Access Compliance Report

Public Rights-of-Way

Intersection ID: 31204	Main Street: GOODLOE_DR	Cross Street: SANDPINES_LN	Location: W
ADA ID: 89A1D2155C89	Ramp Type: PerpDiag	Initial Pass/Fail: Fail	Overall Compliance: No
		Severity Score: 10

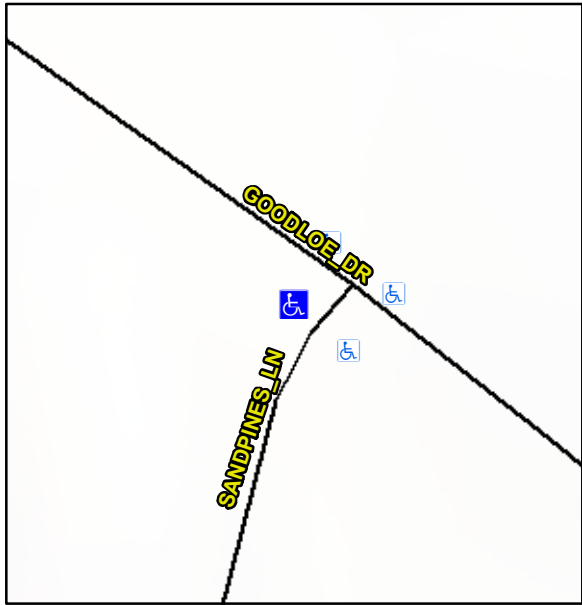
Codes/Mitigation Info/Possible Solution			Field Measurements/Component Compliance					
 <p>Street 1 Name SANDPINES LN</p> <p>Stop Condition-Street 2 StopSign</p> <p>Street 2 Name GOODLOE DR</p> <p>Stop Condition-Street 1 None</p>	Possible Solutions:		Compliance	Description	Data	Compliance	Description	Data
	Remove & Replace Curb Ramp With Two New Directional Ramps or Equivalent.		N/A	Ramp Length (in)	47.0	Yes	Ramp Slope (%)	5.5
			No	Ramp Width (in)	41.0	No	Ramp XSlope (%)	3.6
			N/A	Flare Type LT	N/A	N/A	Flare Type RT	N/A
			N/A	Flare Slope LT (%)	N/A	N/A	Flare Slope RT (%)	N/A
			N/A	Flare Traversable LT?	N/A	N/A	Flare Traversable RT?	N/A
			N/A	Landing Length (in)	N/A	N/A	DWS Provided?	N/A
			N/A	Landing Width (in)	N/A	N/A	DWS Contrast?	N/A
			N/A	Landing Slope (%)	N/A	N/A	DWS Length (in)	N/A
			N/A	Landing X Slope (%)	N/A	N/A	DWS Full Width?	N/A
Surveyor Notes:			N/A	Landing Curb? (Y/N)	N/A	N/A	DWS Offset (in)	N/A

N/A			N/A	Shared Landing?	N/A			
PROW/ADA:			N/A	Gutter Ponding?	N/A	N/A	Gutter Slope (%)	N/A
Not Found, R304.5.1, R304.5.3			N/A	Gutter Lip Ht (in)	N/A	N/A	Gutter X Slope (%)	N/A
			N/A	Painted X Walk1?	No	N/A	Painted X Walk2?	No
				X Walk 1 Direction	To SE		X Walk 2 Direction	To NE
			N/A	X Walk 1 Width (in)	N/A	N/A	X Walk 2 Width (in)	N/A
				X Walk 1 Slope (%)	1.2		X Walk 2 Slope (%)	3.3
				X Walk 1 X Slope (%)	2.7		X Walk 2 X Slope (%)	4.5
			N/A	Ramp inside XWalk1?	N/A	N/A	Ramp inside XWalk2?	N/A
				Road Slope (%)	1.2	N/A	Clear Space?	N/A
				Road X Slope (%)	6.5	N/A	Clear Space to XWalk (in)	N/A
			N/A	Any Obstructions?	N/A	N/A	Storm Grate/Utility Hazard?	N/A
				Obstruction Type			Storm Grate/Utility Type	
					N/A			N/A
						Yes	Surface Condition? (G/P)	Good
Total Cost:		\$ 3200.00
